SERVICE BULLETIN

SUBJECT: LAMP CIRCUIT COUNTERMEASURE

MODEL: Various Audio Receivers **NUMBER:** SB-9431-B

SUBJECT: Correction of Service Bulletin SB-9002-B **DATE:** September 1994

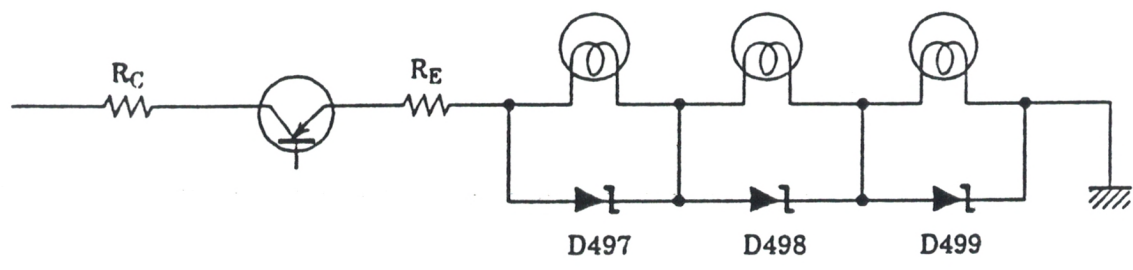
WHEN THE LAMPS BURN OUT, DIODES D497, 498 & 499 SHORT AND BURN THE PCB. TO PRVENT THIS FROM HAPPENING AGAIN, CHANGE THE LAMPS AND THE THREE DIODES. USE THE NEW PART NUMBER SHOWN BELOW AND KEEP THE DIODES 1/4 INCH OR MORE ABOVE THE PCB USING A SPACER (E48269-001) ON EACH LEAD.

Previous MTZ12JC (500mW)
 ↓
 New RD12FB3 (1000mW)

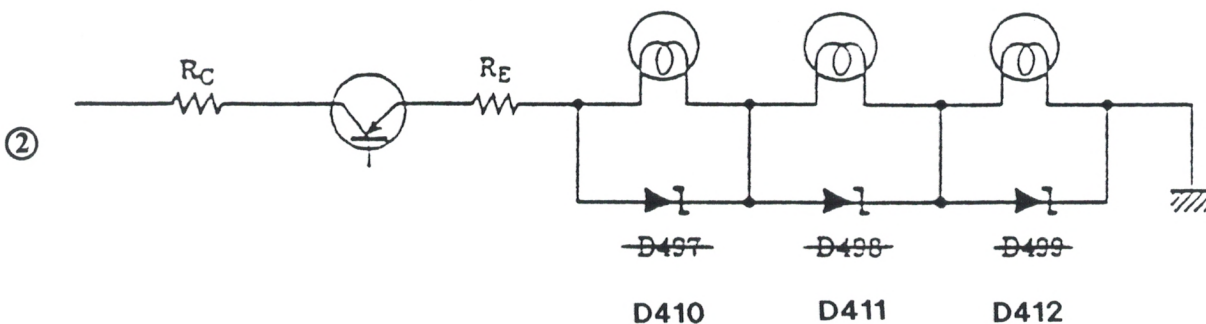
The information contained in Service Bulletin SB-9002-B August 1990 was incorrect for the following four models, and should be corrected:

- ① When any of the lamps burn out, diodes **D410**, **D411**, and **D412** may short. To prevent this from happening again, change the lamps and the three diodes. Use the new part number shown below and keep the diodes 1/4 inch or more above the PCB using a spacer (p/n E48269-001) on each lead.

Incorrect	Correct
Previous MTZ12JC (500 mW)	Previous p/n MTZ8.2JC (500 mW)
↓	↓
New RD12FB3 (1000 mW)	New p/n RD8.2FB3 (1000 mW)
